City Planning Commission
Sacramento, California

Subject: Special Permit Modification for 830 L Street (P87-456)

ROOF PLAN

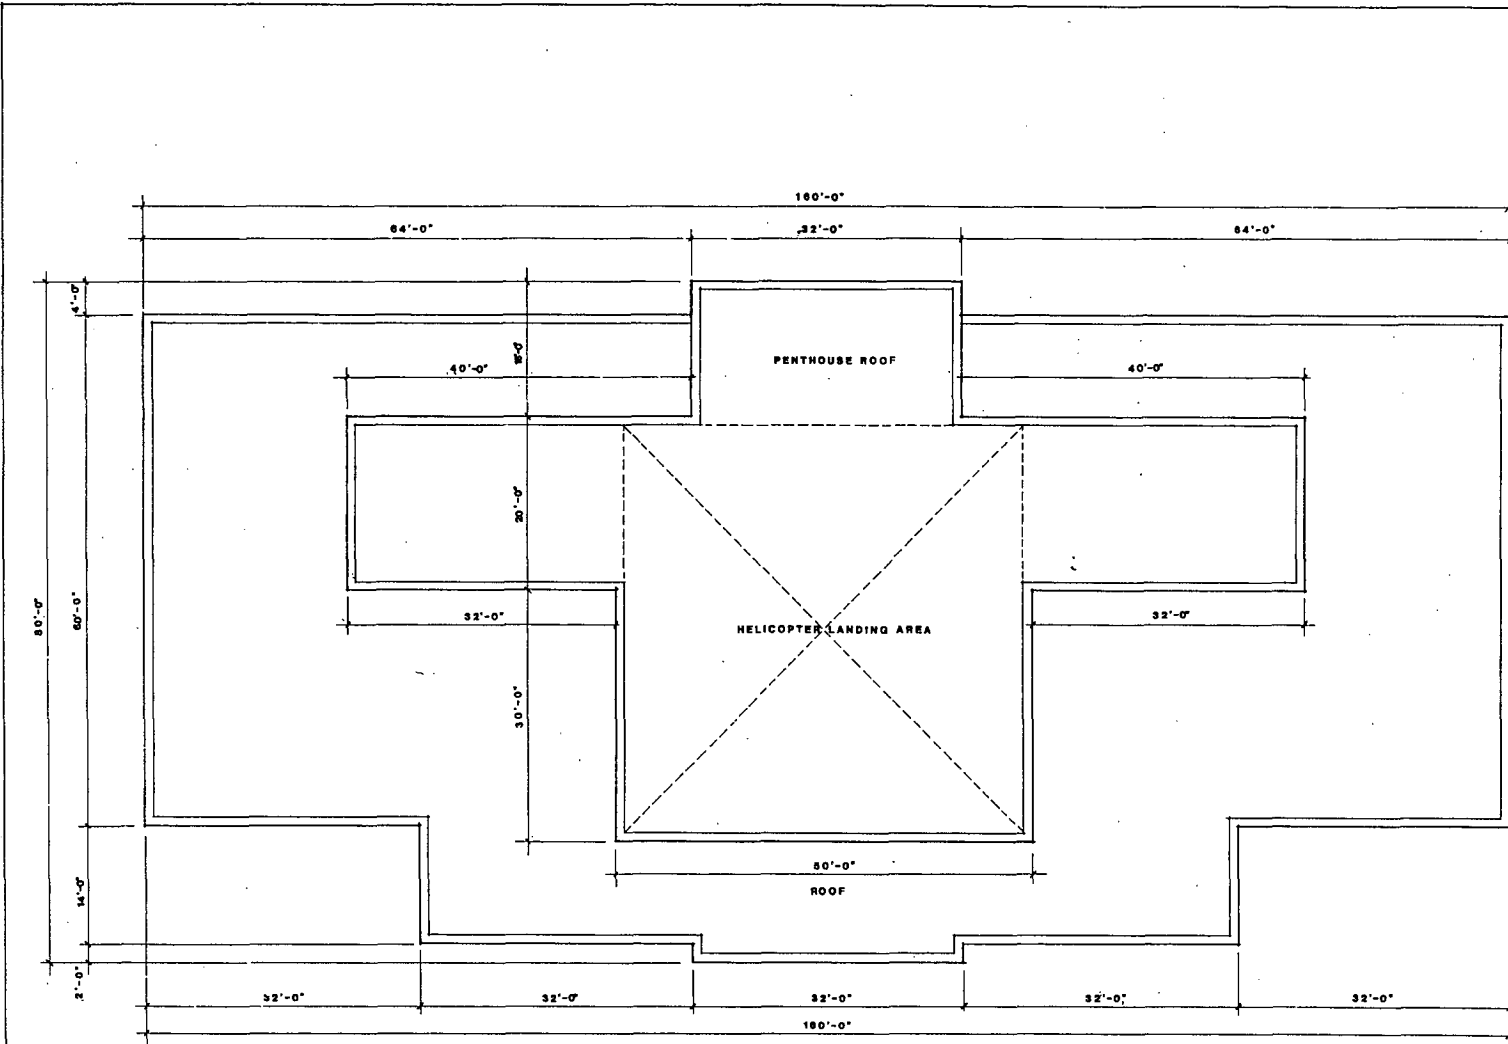
6. A rooftop plan shall be submitted. All rooftop mechanical equipment shall be located within a penthouse structure or screened.
 7. A detailed exterior lighting plan shall be developed which provides for lighting of building perimeter and security lighting of alley.

SOUTH ELEVATION

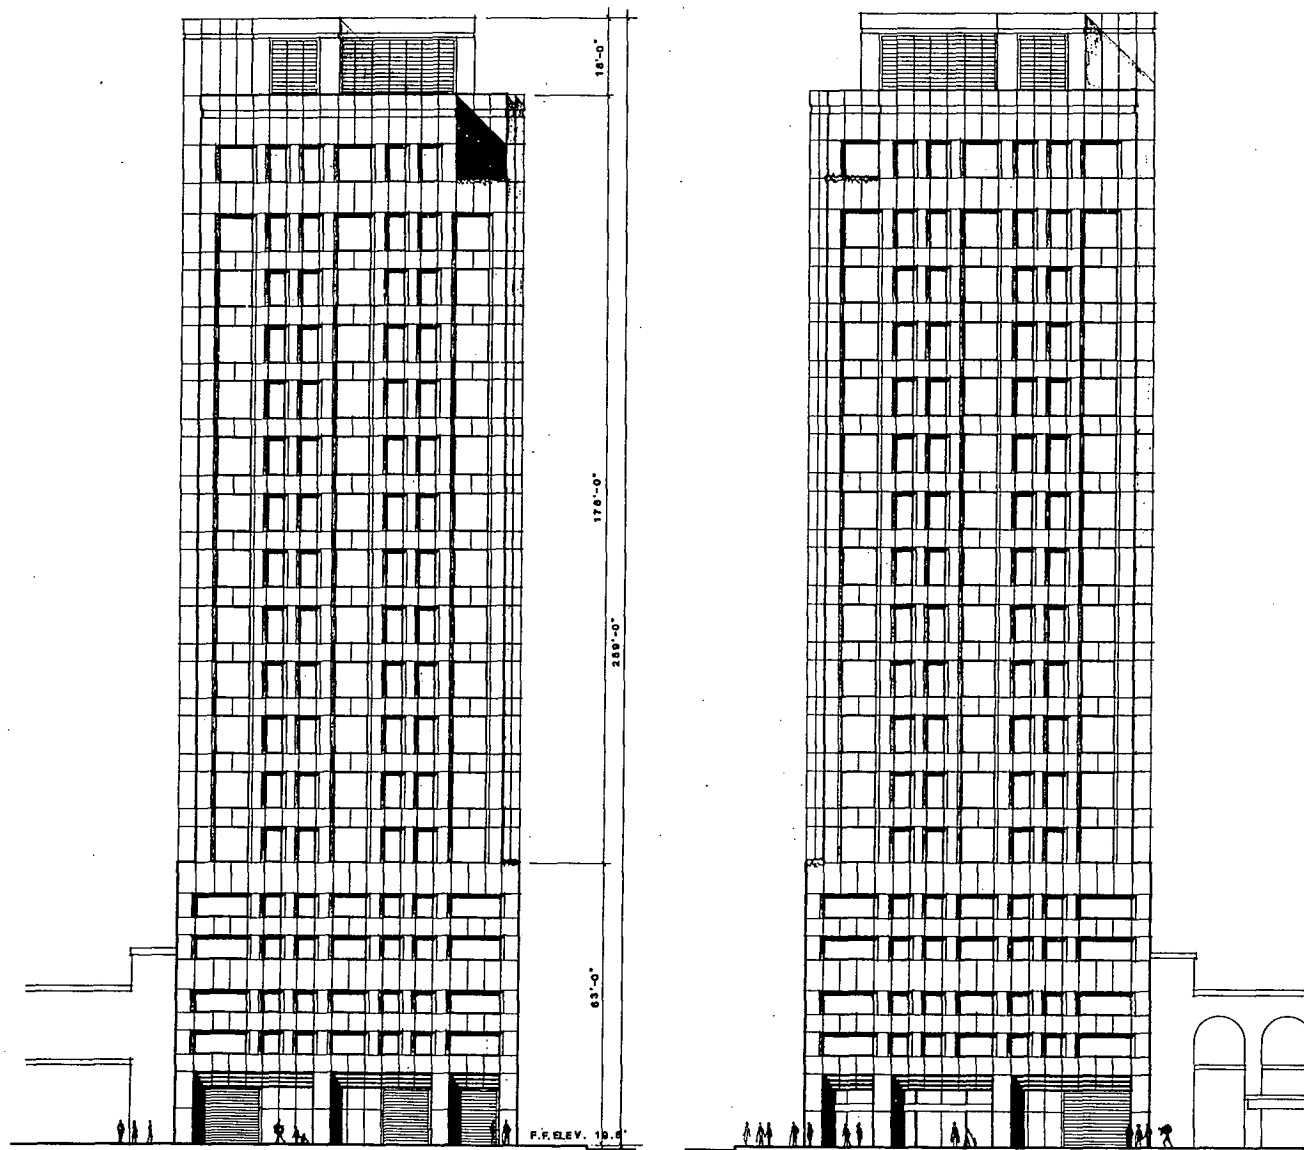
- (Delete per DR/PB)
4. Materials and design treatment used on the 9th and L Street facades should also be used on the alley facing facade.
 5. The exterior facade of the elevator tower on the west elevation should be enhanced through a change in surface texture and/or color as suggested in subparagraph 2 above.
